CERTIFICATE OF APPROPRIATENESS PLACARD

821 RUNNYMEDE ROAD

MATSUMOTO HOUSE

Raleigh Historic Development Commission – Certificate of Appropriateness (COA) Application

LANDSCAPE PLAN FOR HUSTON PASCHAL 321 RUNNYMEADE RD. OCT. 21, 2014 EPA

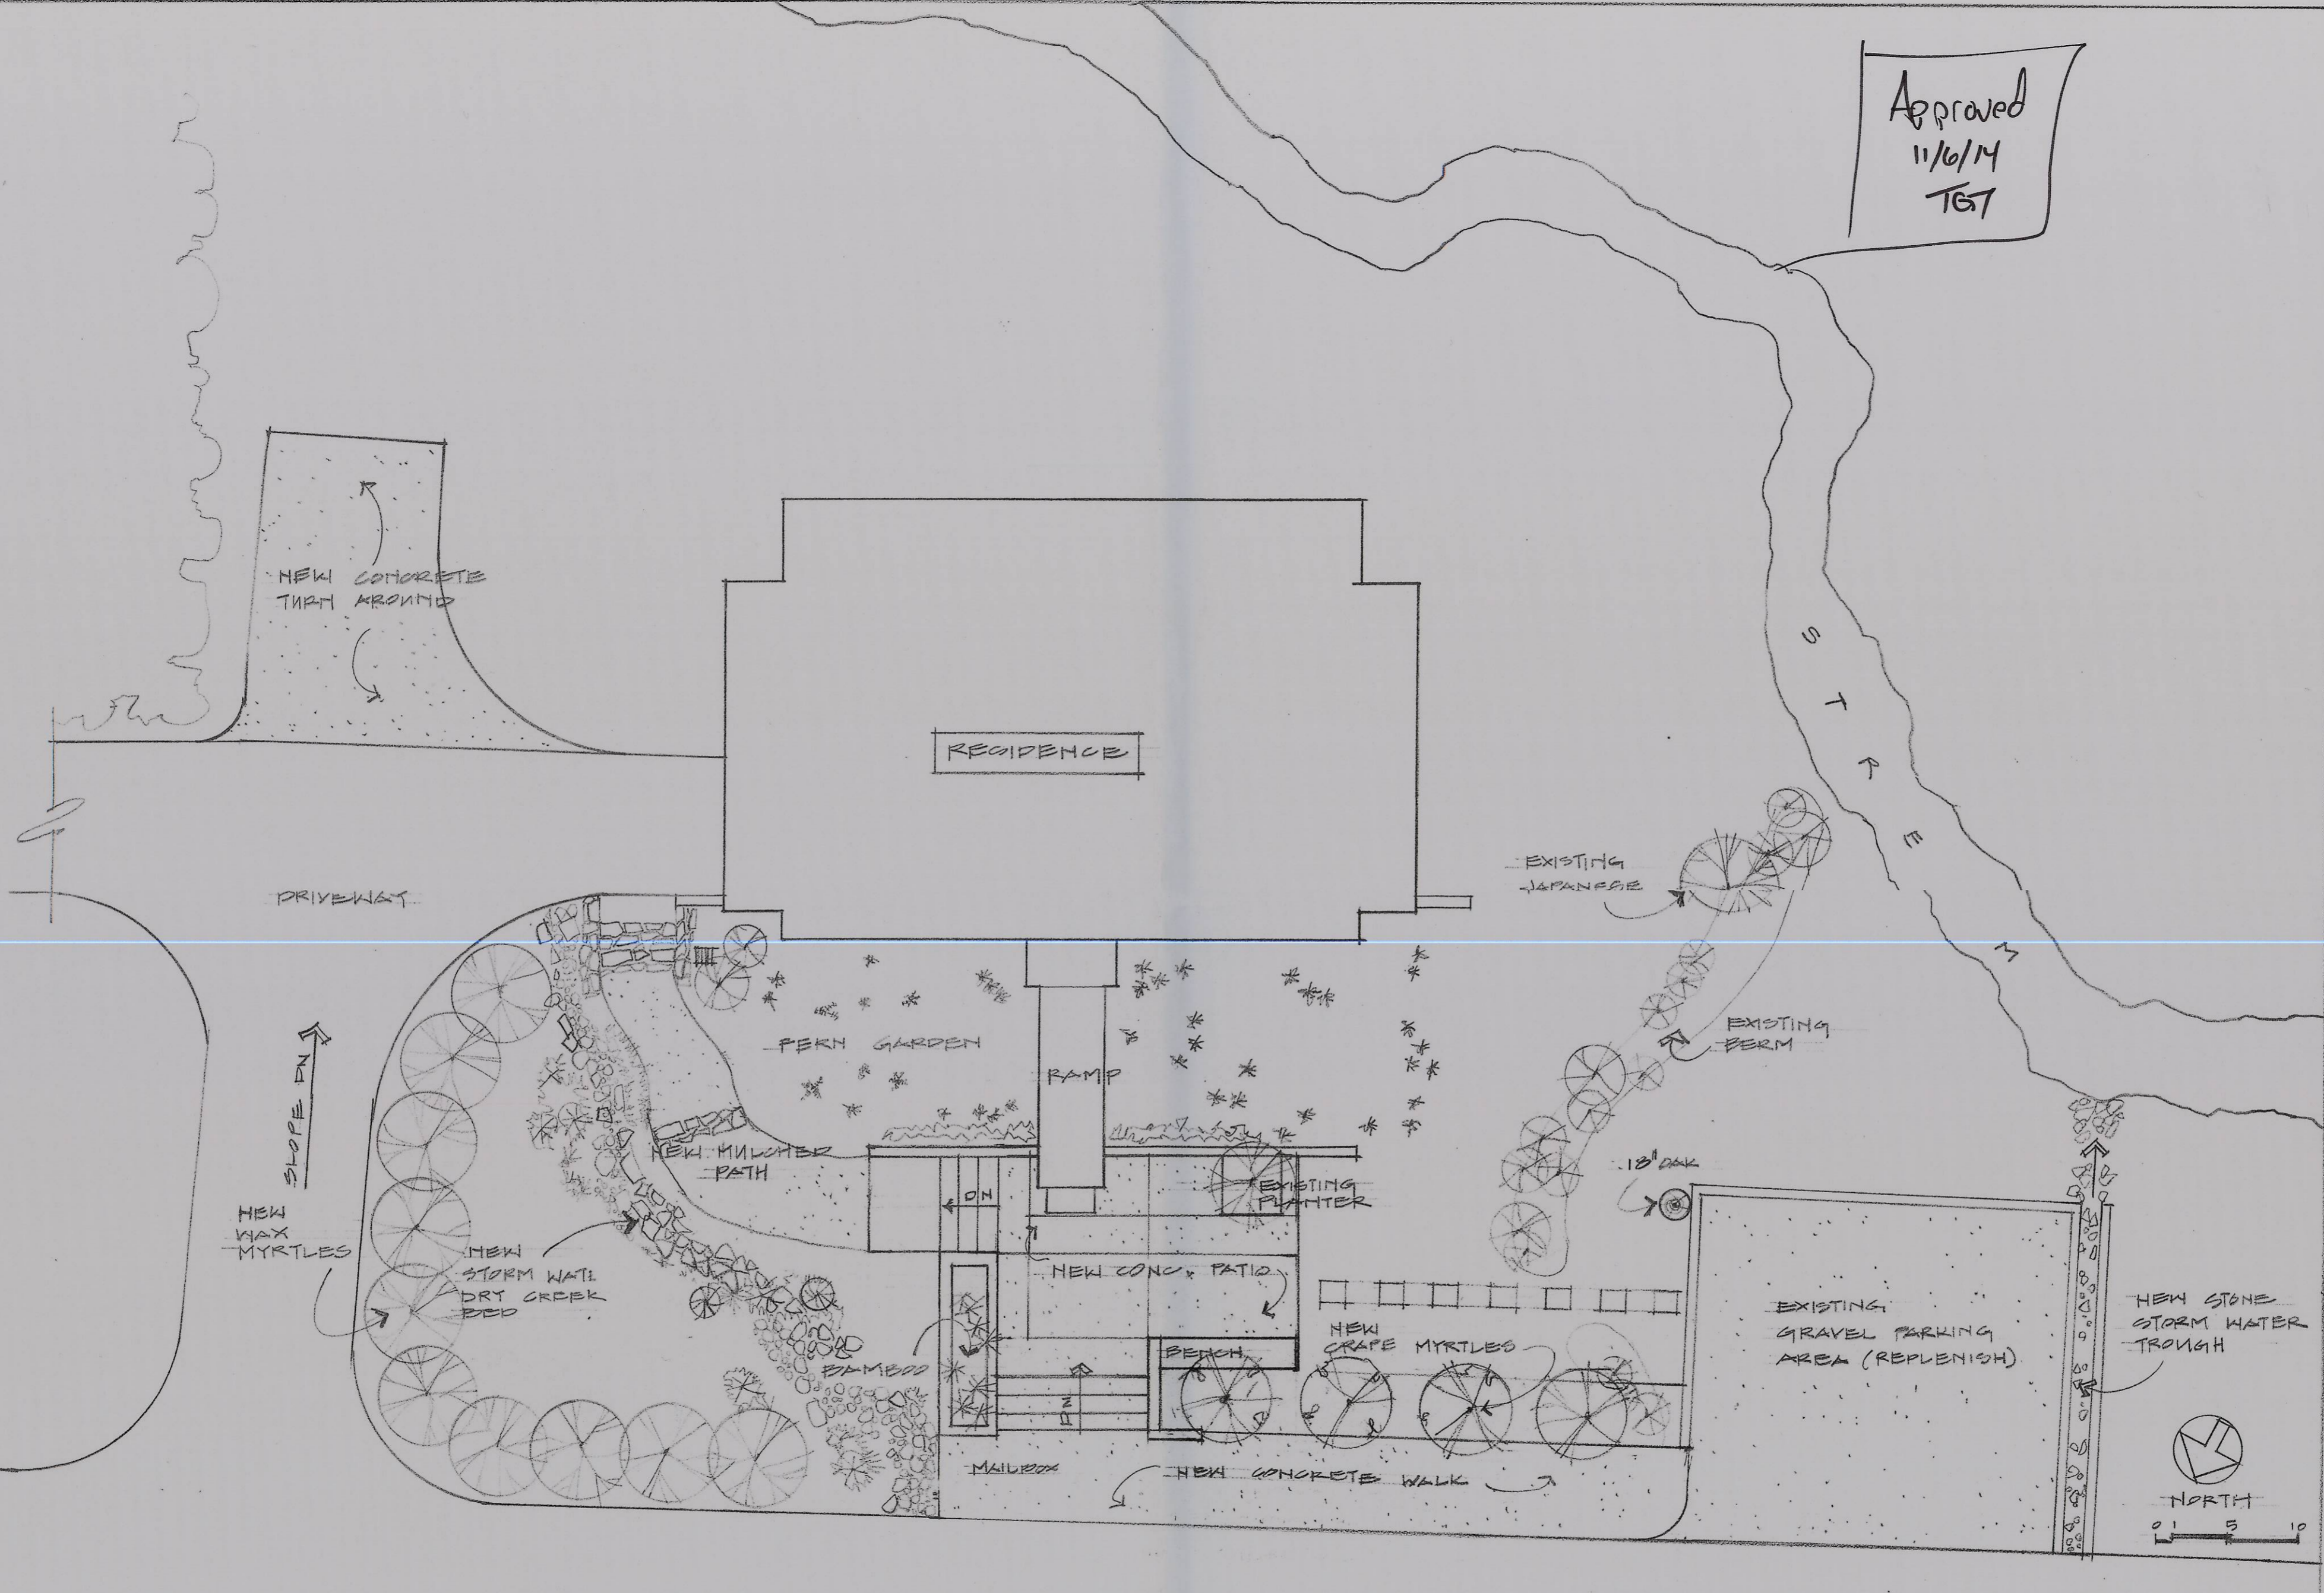
Not part of this application. TGT

ok see photo TGT

Approved
11/6/14 TGT
